# Riverside Energy Park

## Applicant responses to Relevant Representations

**8.02.03**

May 2019 | Revision 0 (Deadline 2)

Figure 6.1: Scenarios 1, 2a, 3b and 4 of the London Waste Strategy Assessment, at 2026

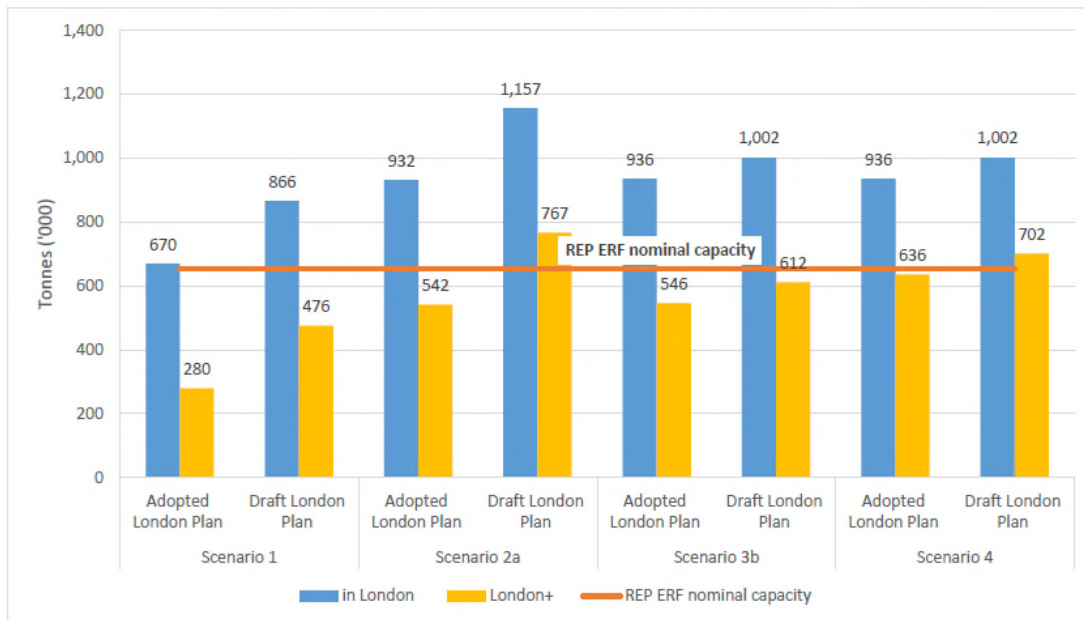
will be required if London is going to achieve self-sufficiency and diversion from landfill targets. This is readily demonstrated by Figure 6.1 of the LWSA, reproduced below which examines residual waste treatment capacity need against a range of recycling and projected tonnage assumptions set out in the London Plan, Draft New London Plan and London Environment Strategy .

- 2.5.7 The LWSA demonstrates that REP is appropriately sized to make a beneficial contribution to London achieving its policy goals of being a zero carbon city and sustainably managing its own residual wastes. In addition, the LWSA identifies c.2 million tonnes of residual wastes in from authorities in the South East that should also be diverted from landfill.

- 2.5.8 In any event, policy is clear that the role of planning is not to limit the amount of new energy generation capacity, particularly when that provides a supply of renewable/low carbon power. As is made clear at **Section 2.2** of the **PBR (7.2, APP-103)**, the NPS sets no cap on the amount of new generation capacity that should be delivered, not least at paragraph 3.3.24 the Government confirms that it is not its intention to ‘set targets or limits on any new generating infrastructure to be consented in accordance with the energy NPSs. It is not the IPC’s role to deliver specific amounts of generating capacity for each technology type’.

Figure 1: Extract from LWSA (Annex A, PINS Reference APP-103) of Figure 6.1 - Scenarios 1, 2a, 3b and 4 of the LWSA at 2026

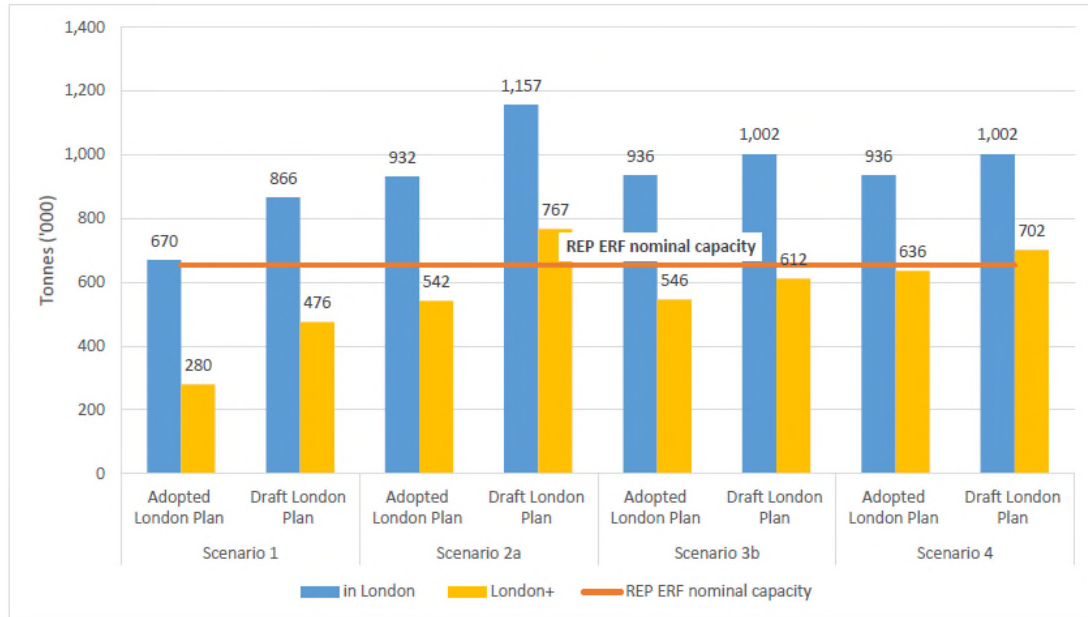
4.4.31 The LWSA has been undertaken using data and policy priorities from the adopted London Plan, the draft London Plan and from the London Environment Strategy. The LWSA concludes that even in the most conservative assessment, using the lowest waste arisings and the aspirational policy expectations regarding waste management, at least one third of the nominal throughput of the capacity of REP (principally the Energy Recovery Facility, the 'ERF') is required to sustainably manage London's residual waste. A more realistic level of need, calculated through using actual waste arisings and applying recycling objectives of the London Environment Strategy, demonstrates that all, if not more, of that nominal throughput will be required if London is going to achieve self-sufficiency and diversion from

landfill targets. This is readily demonstrated in Figure 6.1 of the **LWSA**, reproduced below as Figure 1.

Figure 2: Daily traffic flow profile on A2016 Bronze Age Way

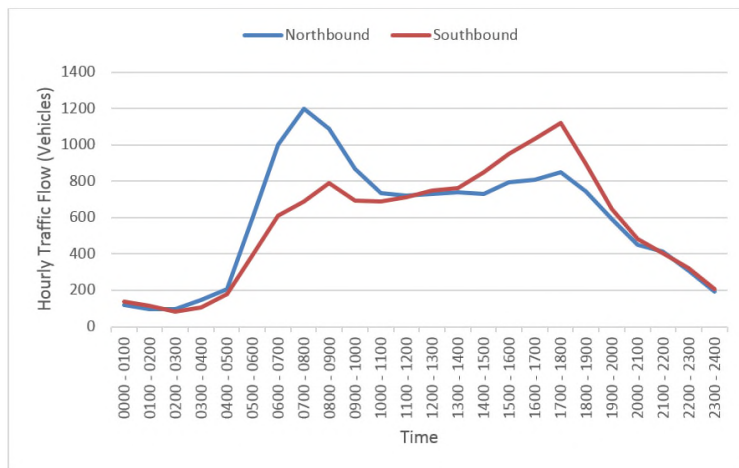
- 5.11.20 Data were collected at approximately 40m to the south of Picardy Manorway / Anderson Way roundabout and on A206 Northend Road at approximately 110m to the north of A206 Northend Road / A2000 Perry Street / Parkside Avenue roundabout. The data were collected across two weeks between 14 April 2018 to 27 April 2018. The average weekday hourly traffic profiles are illustrated in **Figure 2** and **Figure 3** below.

5.11.21 The Design Manual for Roads and Bridges (DMRB) Volume 5 Section 1 Part 3 TA 79/99 Amendment No 1 – Determination of Urban Road Capacity, Table 1 'Types of Urban Roads and the features that distinguish them', provides guidance as to the classification of route for the A2016/A206 corridor. Table 2 'Capacities of Urban Roads one-way hourly flows in each direction' provides a guide to the volume of traffic each type of route might be expected to carry.

5.11.22 In accordance with those tables, the dual carriageway sections of A2106 and A206 would be classified as Urban All-purpose class 2 (UAP2) routes – i.e. dual carriageways of approximately 7.3m width per carriageway and 2 lanes in each direction. UAP2 class routes should be able to carry in the region of 3,200 vehicles per hour in either direction across both lanes – remote from the interaction with junctions. Each lane would have a capacity in the order of 1,600 vehicles per hour.
